# PIC18F2525/2620/4525/4620

## PIC18F2525/2620/4525/4620 Rev. A3 Silicon Errata

The following silicon errata apply only to PIC18F2525/2620/4525/4620 devices with these Device/Revision IDs:

**FIGURE 1: SCK PULSE VARIATION USING TIMER2/2**

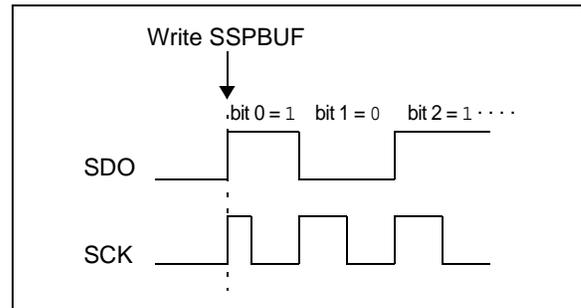
When the SPI is using Timer2/2 as the clock source, a shorter than expected SCK pulse may occur on the first bit of the transmitted/received data (Figure 1).

To avoid producing the short pulse, turn off Timer2 and clear the TMR2 register, load the SSPBUF with the data to transmit and then turn Timer2 back on. Refer to Example 5 for sample code.
